Self Calibrating Digital Control

GENERAL SOUND WIRING OPTION

PRODUCT INFORMATION BULLETIN # 4604

GENERAL SOUND WIRING OPTION

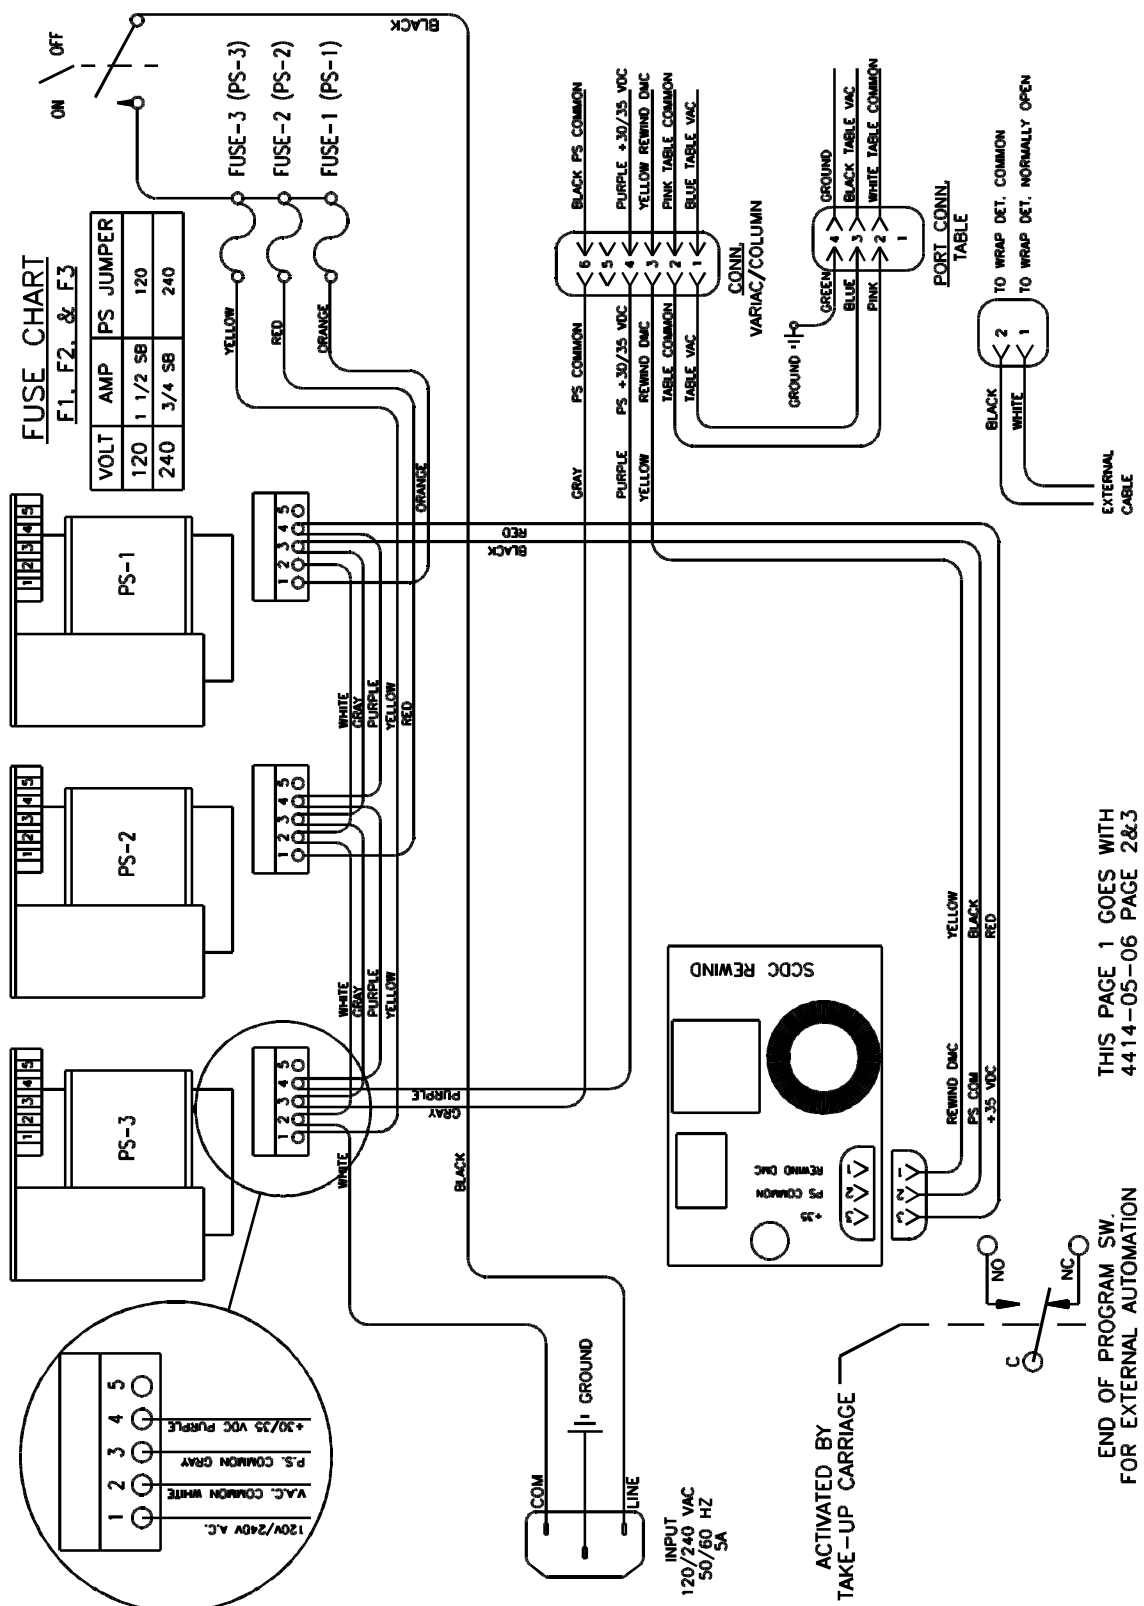
NOTE: The following changes were made to the **standard** SCDC Platter System.

1. Column Wiring: No Change
2. Arm Wiring: No Change
3. Power Supply Wiring:
 - ! Removed Wrap Detector Timer Card
 - ! Installed 15' two conductor external cord wired to the (Normally Open) contacts of the Wrap Detector switch.
